Sydney Metro Sydenham to Bankstown Ancillary Facility Checklist

Assessment Name	Carrington Road Ancillary Facility and Laydown
Location	Way Street, Marrickville
Prepared By	Chris McCallum
Revision	Rev 2
Date required by	23 September 2023

Handover Sydney Metro Principal Contractors Form

DRAWING TITLE:
COMPOUND SERVICE PROTECTION MEASURES
SITE PLAN

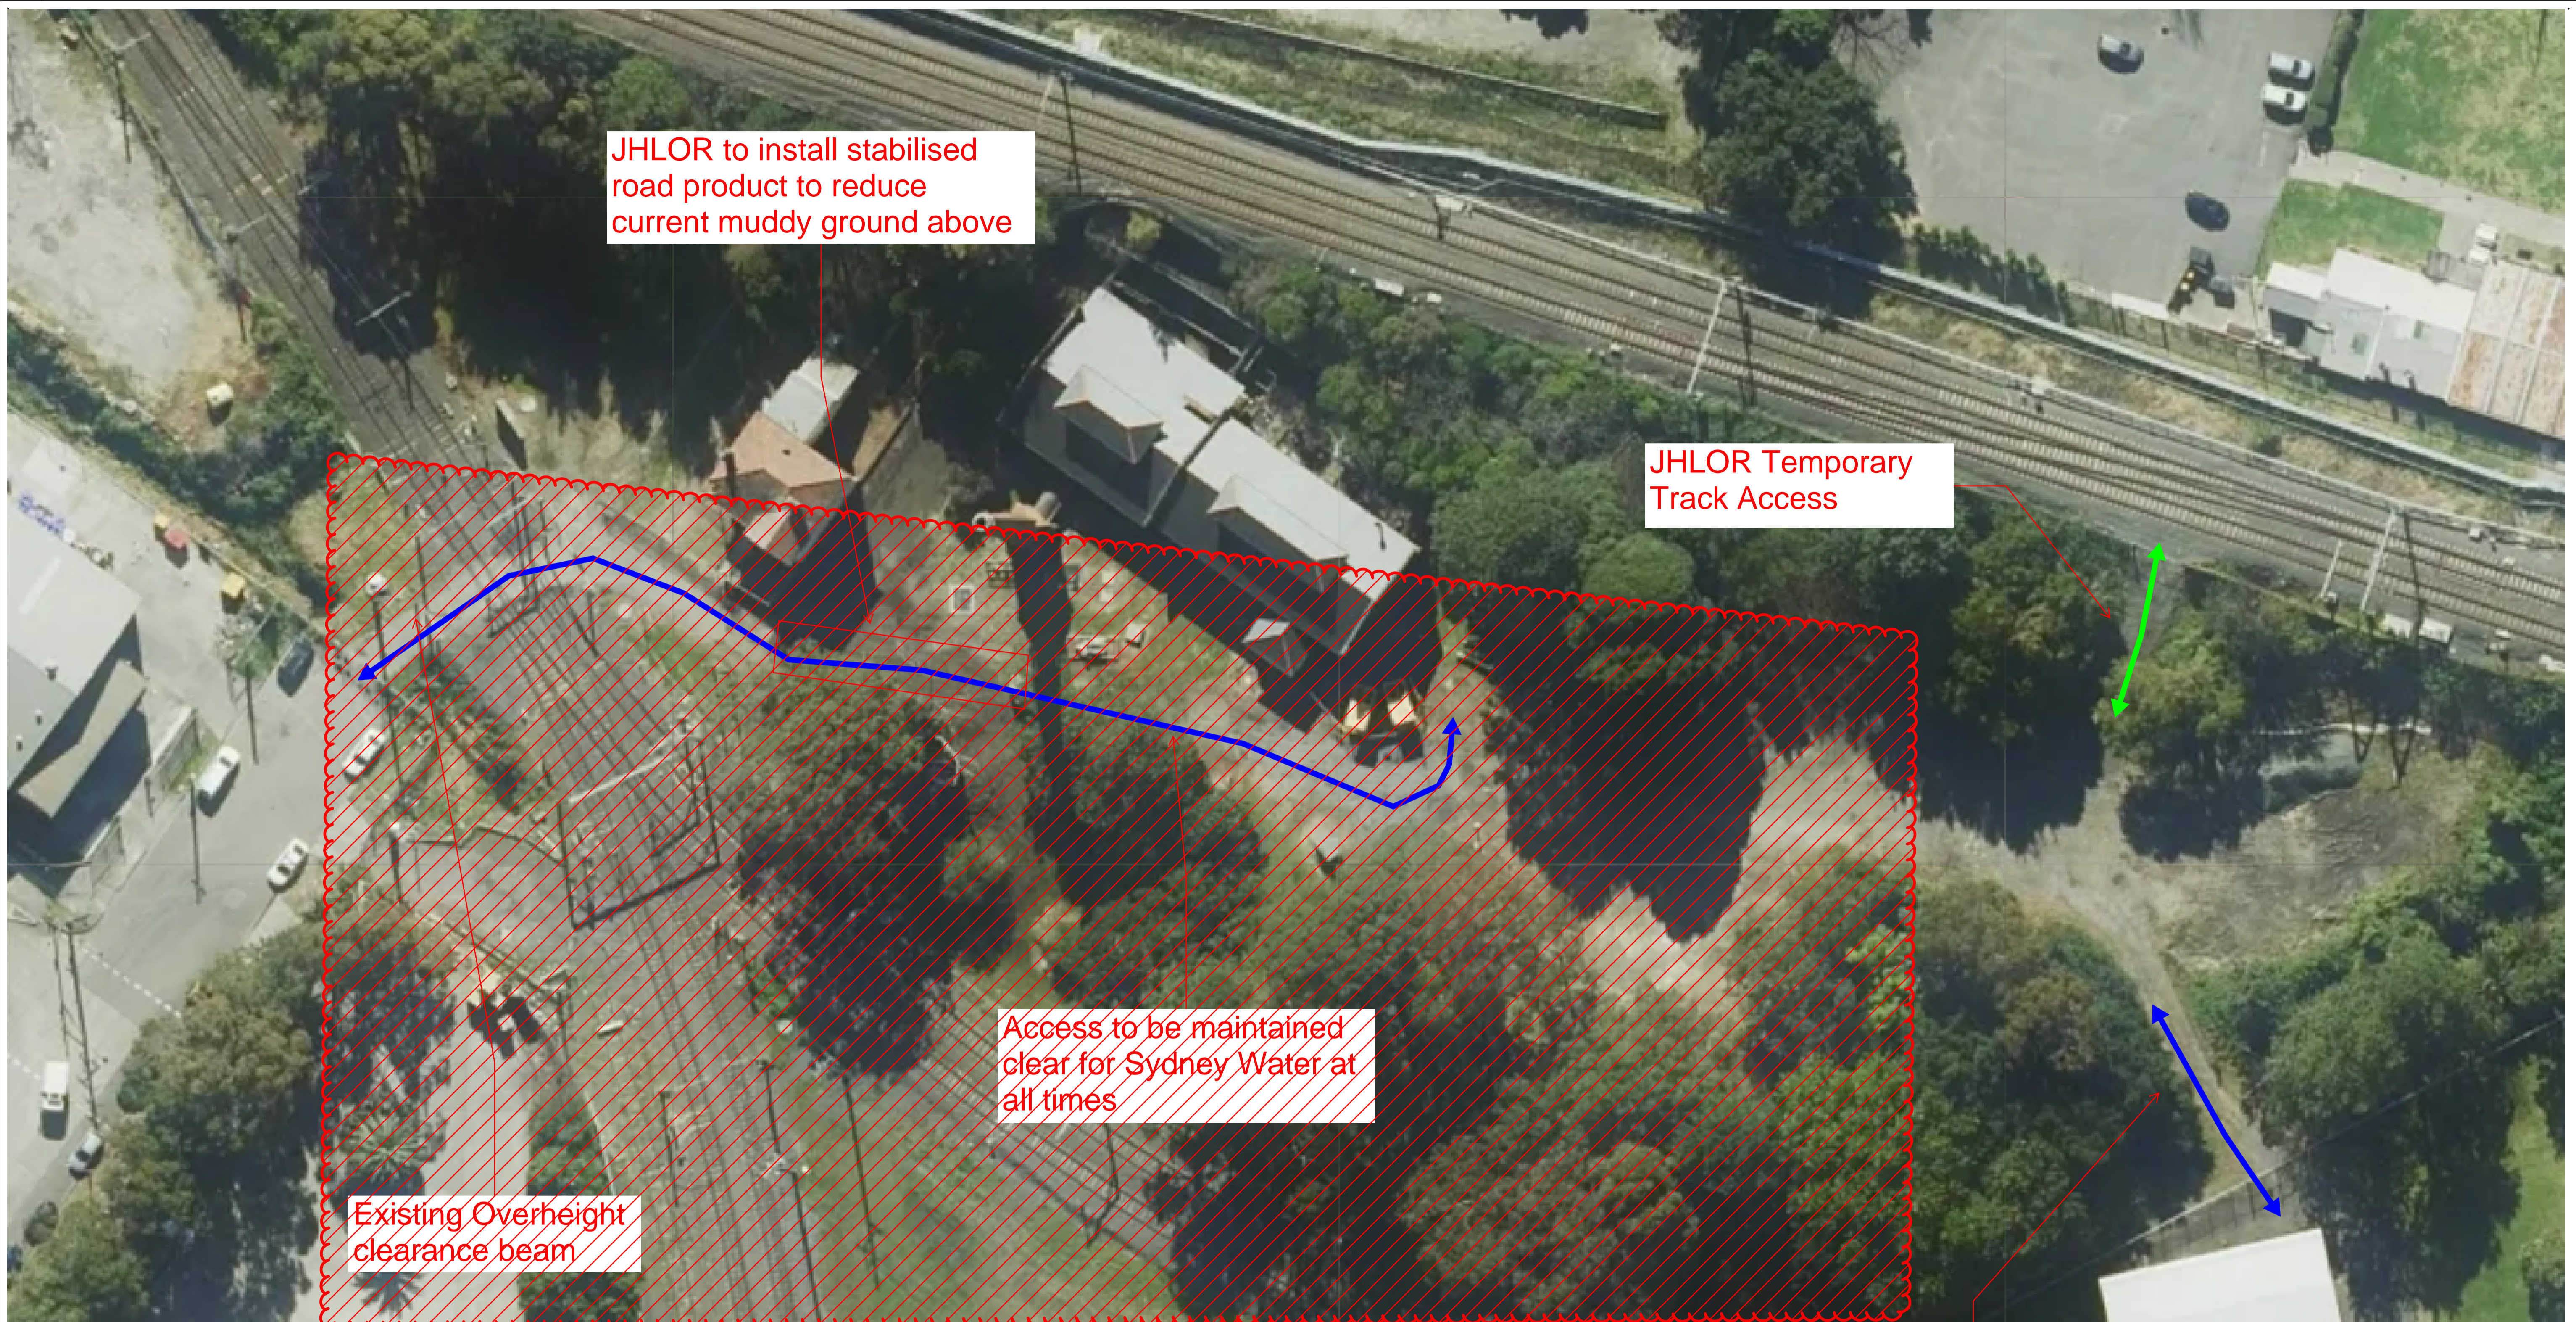
JHLOR to install stabilised road product to reduce current muddy ground above

Access to be maintained clear for Sydney Water at all times

Access to be maintained clear for Sydney Water or others at all times

**EXCLUSION ZONE
ACCESS PENDING SWC AGREEMENT
UPDATED TEMPORARY WORKS DESIGN FOR SHALLOW ASSETS**

EXTERNAL REFERENCE FILES: XXXXX	SCALES @ A1: 1:5 @ A1 	ISSUE STATUS: 		ON BEHALF OF: 	PROJECT: SWMC MARRICKVILLE CARRINGTON ROAD
					DRAWING TITLE: COMPOUND SERVICE PROTECTION MEASURES SITE PLAN
					DRAWN: NTS DESIGNER: DRG No: REV
					SCALE: NTS DATE: 14/09/2023 TWDB688 GA-01 P2

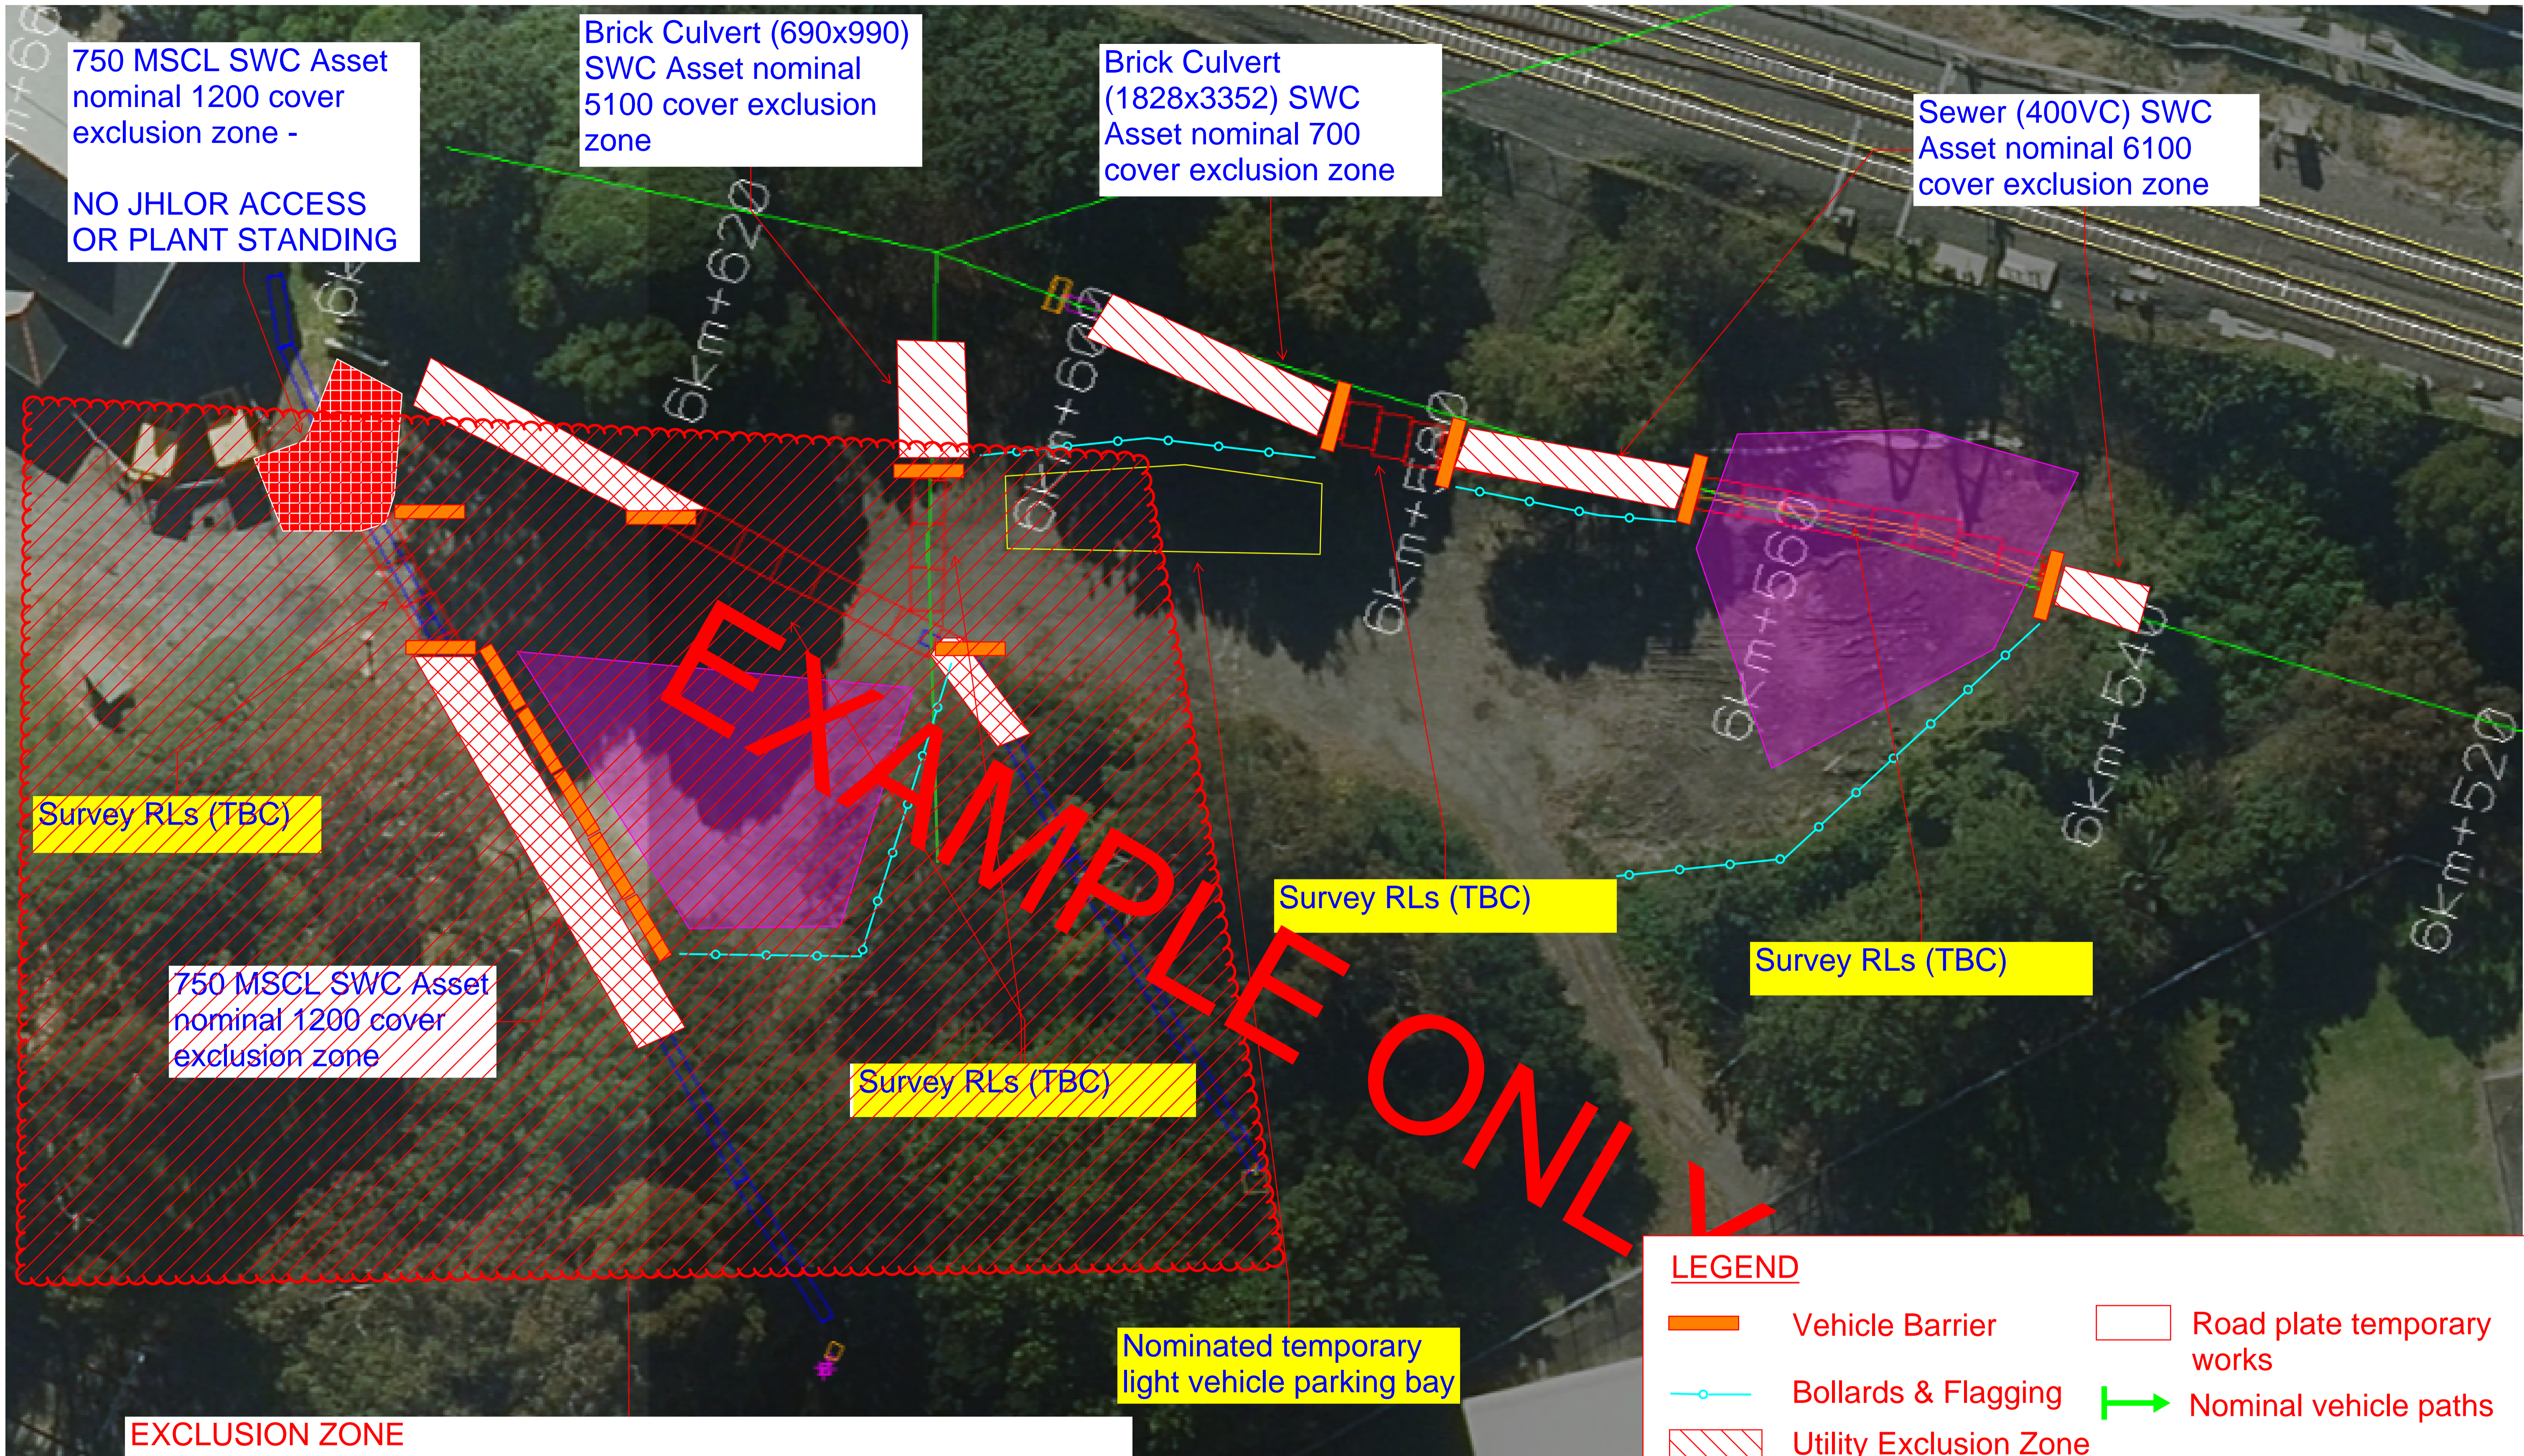
750 MSCL SWC Asset nominal 1200 cover exclusion zone -
NO JHLOR ACCESS OR PLANT STANDING

**EXCLUSION ZONE
ACCESS PENDING SWC AGREEMENT
UPDATED TEMPORARY WORKS DESIGN FOR SHALLOW ASSETS**
